ADDENDUM NO. 2

Bid #1459

Building G Mechanical Insulation Repairs Project

Santiago Canyon College

Item No. AD 2-2 Scope of Work – Floor Protection Clarification

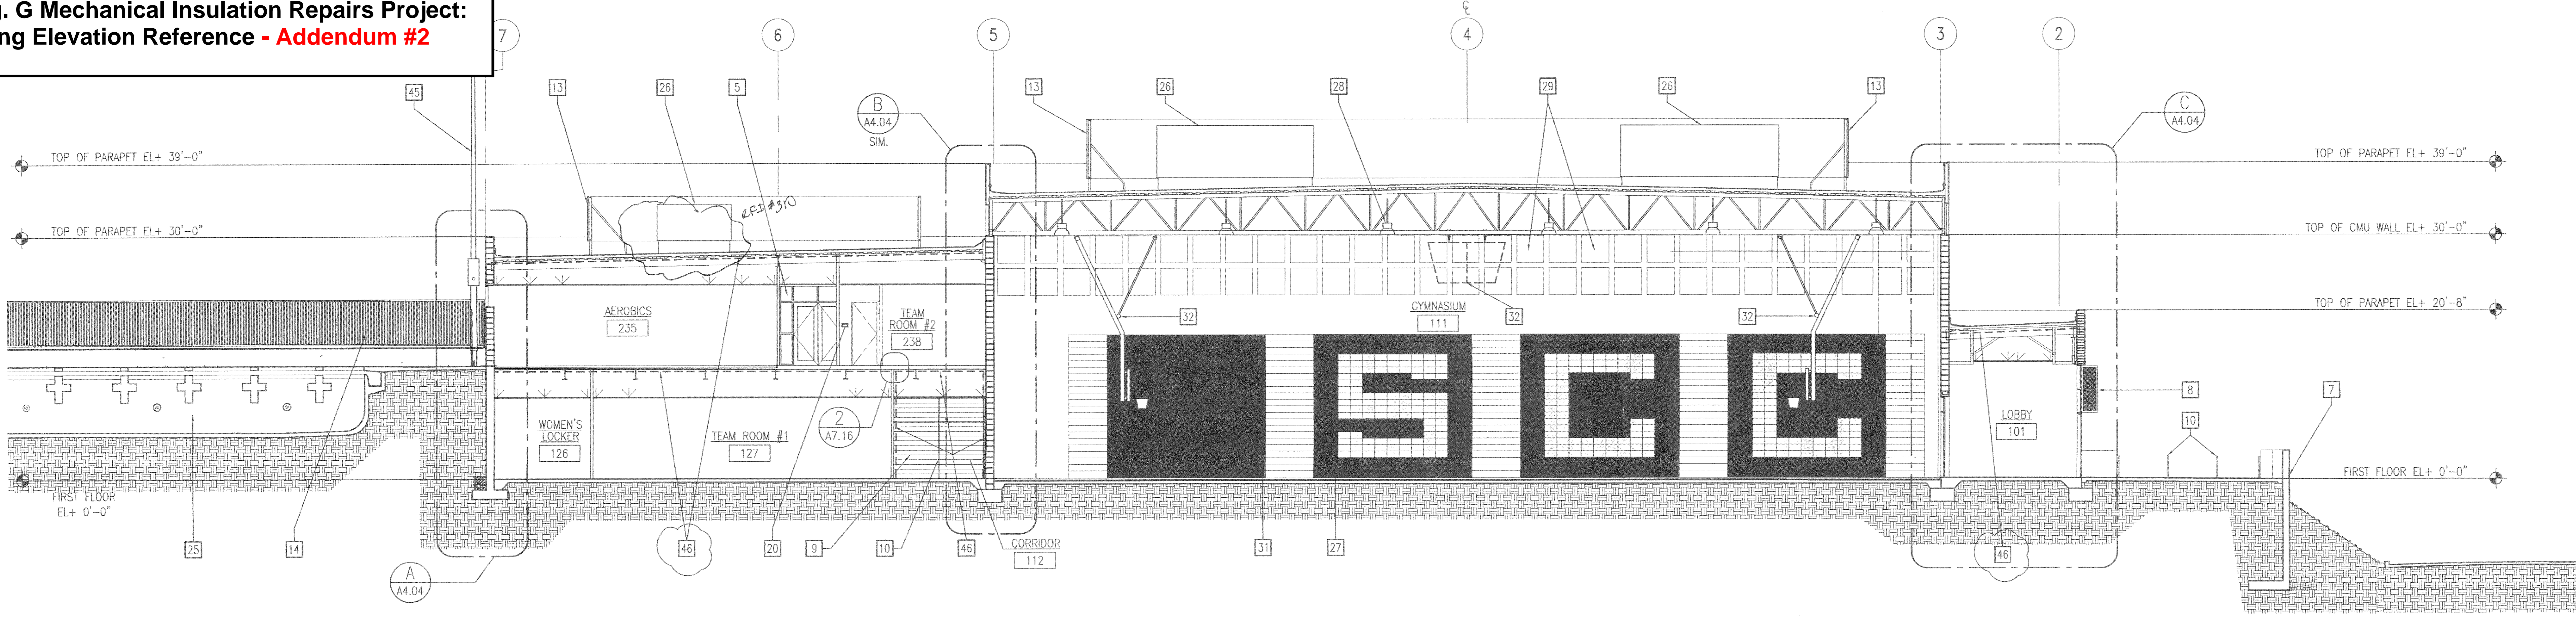
Contractor to assume basketball courts located in the Gymnasium are to be used during the day by students and faculty. Gymnasium floor protection to be removed at the end of each working shift and re-applied prior to commencing work the next shift.
